Re: Duplexes for the Constance LLC
4505 12TH St. NW
Traffic Circulation Layout
 Architect's Stamp 03-15-23 (G14-D080A)

Based upon the information provided in your submittal received 04-28-23, the above referenced plan cannot be approved for Building Permit until the following comments are addressed:

1 TRAFFIC CIRCULATION LAYOUT - TCL - 4505 12th St. NW

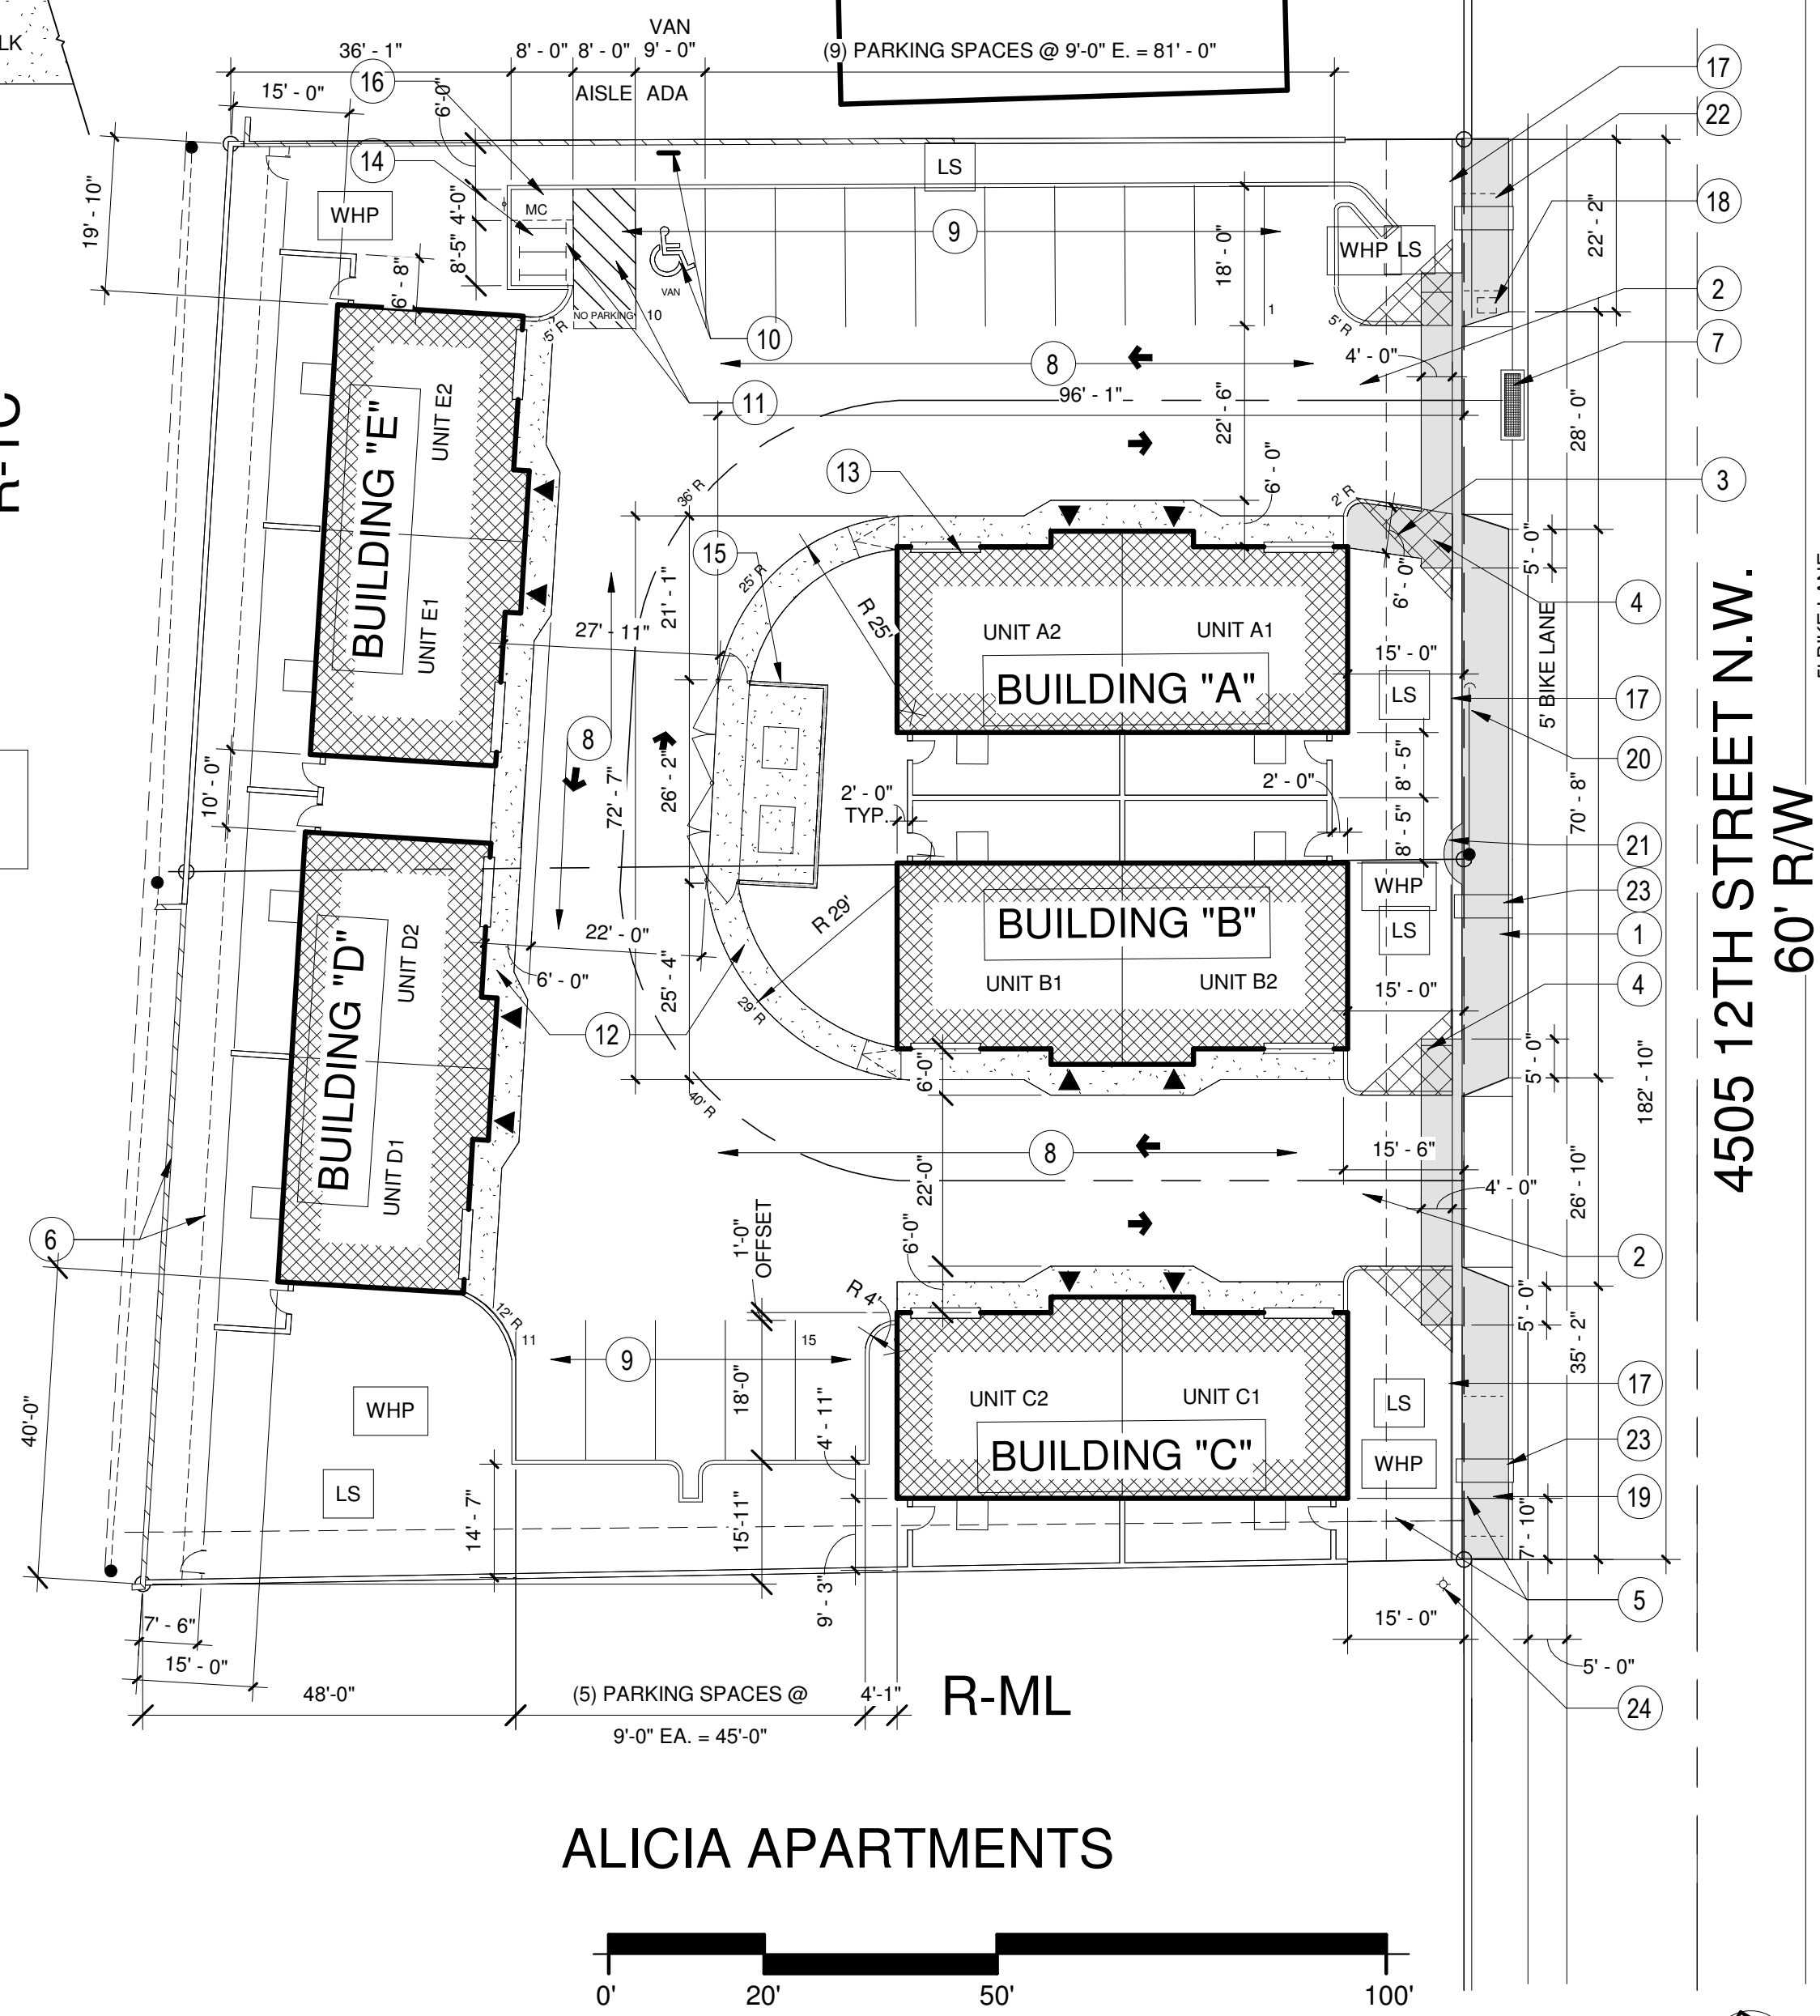
1. Identify all existing access easements and rights of way width dimensions.
2. Please show on the site plan the throat length for the north site access. Per the DPM the minimum throat length should be 25 ft.
3. Please explain how the motorcycle could park in the proposed MC parking. Please provide internal circulation that the driver can easily follow.
4. Provide sidewalk easement for the proposed 4 ft. wide sidewalk at both accesses (see the highlighted area). For sidewalk easement, please contact Carrie Mouck at (505)924-3996 camouck@cabq.gov

5. Per DPM, a 6 ft. wide ADA accessible pedestrian pathway is required from the ADA parking stall access aisles to the building entrances. Please clearly show this pathway and provide details.

6. ADA accessible pedestrian pathway should not be placed behind parking space or adjacent to a vehicular way. Vehicle and pedestrian/wheel chair conflicts should be avoided as much as possible.
7. Work within the public right of way requires a work order with DRC approved plans.
8. Please add a note on the plan stating "All improvements located in the Right of Way must be included on the work order."
9. Please provide a letter of response for all comments given.
10. Traffic Studies: See the Traffic Impact Study (TIS) thresholds. In general, a minimum combination of 100 vehicles entering and exiting in the peak hour warrants a Traffic Impact Study. Visit with Traffic Engineer for determination, and fill out a TIS Form that states whether one is warranted. In some cases, a trip generation may be requested for determination (**Contact Matt Grush: mgrush@cabq.gov**).
